APPLICATION NO.	FILING DATE	FIRST NAMED INVENTOR	ATTORNEY DOCKET NO.	CONFIRMATION NO.
10/701,515	11/06/2003	Said I. Hakky	MR2493-38	7376

Office Action Summary	Application No. 10/701,515	Applicant(s) HAKKY ET AL.	
	Examiner Michael G. Bogart	Art Unit 3761

DETAILED ACTION

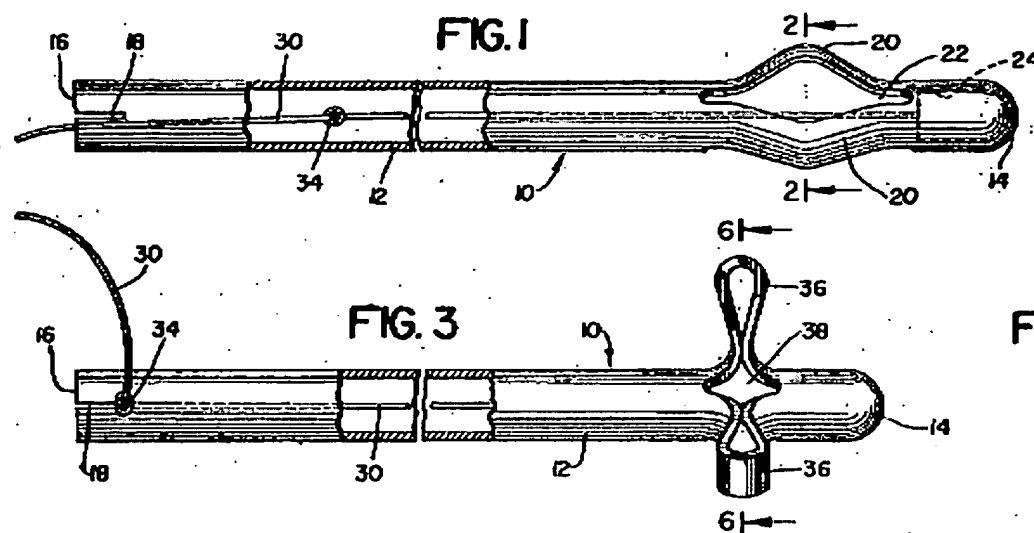
Regarding claim 1, Wallace teaches a self-retaining urinary drainage catheter system (10), comprising:

(a) a longitudinally extending flexible tube (12) having a predetermined outer diameter, an open distal end (16) and a closed proximal end (14), said flexible tube (12) defining at least one lumen, said closed proximal end (14) having a plurality of longitudinally directed slits (22) formed through a wall of said flexible tube (12) defining a plurality of flexible tube (12) slit portions (20, 36); and,

(b) means (30) for reversibly and radially displacing said plurality of flexible tube slit portions (20, 36) of said proximal end (14) to a first configuration (fig. 1) abutting in a non-continuous manner an inner surface of a urinary bladder, said first configuration of flexible tube slit portions (20, 36) having an outer diameter greater than said predetermined diameter of said flexible tube (12) and defining a plurality of drainage apertures (38), and for displacing said plurality of flexible tube slit portions (20, 36) to a second configuration (fig. 2) wherein said plurality of flexible tube slit portions (20, 36) has a diameter substantially equal to said predetermined outer diameter of said flexible tube (12), wherein said means (30) do not substantially obstruct a lumen of said catheter (10), and said catheter (10) is reversably insertable in a human being without using a stylet (see figures 1 and 2, below).

Regarding claims 2 and 8, Wallace teaches that said means (30) further comprises a wire control device (30) longitudinally and slidably positioned within a lumen of said longitudinally extending flexible tube (12), said wire control device (30) fixedly secured at a first end (32) to an inner surface of said closed proximal end (14) and having a length greater than a length of said longitudinally extending flexible tube (12) so that a second end of said wire control device (30) protrudes through said open distal end (16)(figure 1).

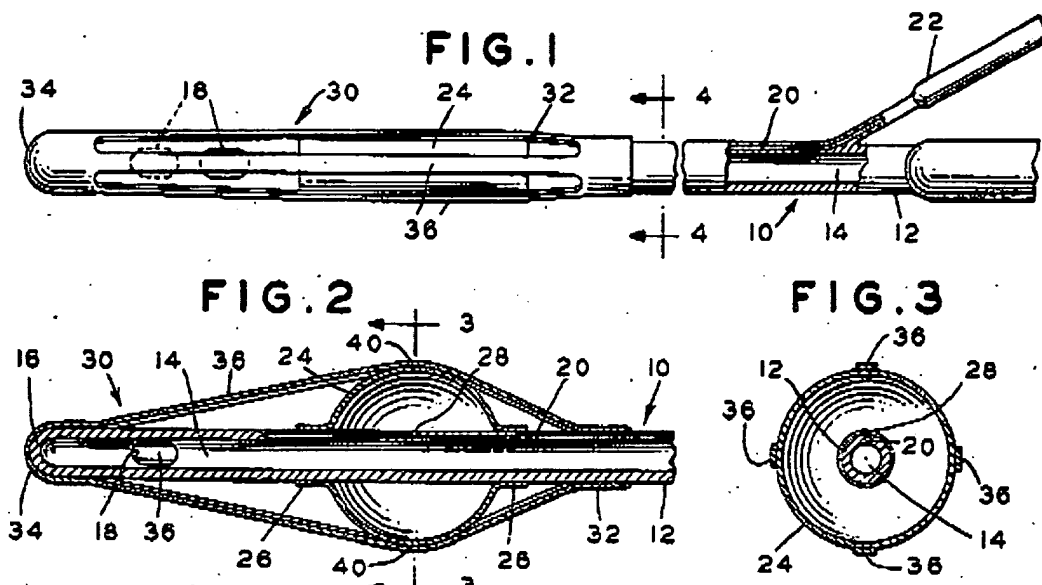
Regarding claims 3 and 12, Wallace teaches that said wire control (30) device further comprises a means (18, 34) for reversibly locking said wire control device (30) in a predetermined position (figure 3).

Regarding claim 7, Wallace teaches that the wire control device (30) is composed of a metal or non-metallic material (polyethylene)(column 3, lines 11-18).

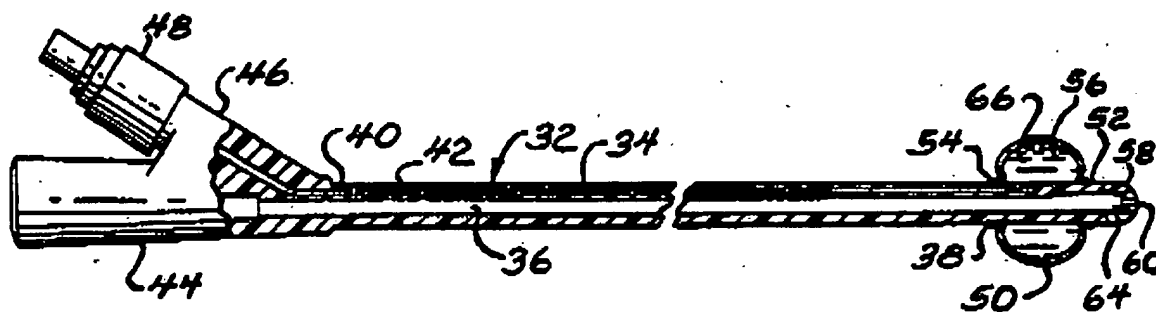
Regarding claims 4 and 9, Baskin teaches that said means (20, 24) for reversibly and radially displacing said plurality of flexible tube slit portions (32) further comprises a reversibly inflatable balloon (24) located between said plurality of flexible tube slit portions (32) and having flexible non-distensible tubing allowing fluid to be reversibly injected therein so as to expand said reversibly inflatable balloon (24).

Baskin does not expressly disclose a valve.

Rosenberg teaches a balloon catheter (32) having a balloon inflation tube (42) that controls fluid flow to the balloon via a valve (48)(figure 6).

At the time of the invention, it would have been obvious to one of ordinary skill in the art to add the valve of Rosenberg to the fluid inflation tube of the catheter of Baskin in order to provide a means of keeping the balloon inflated.
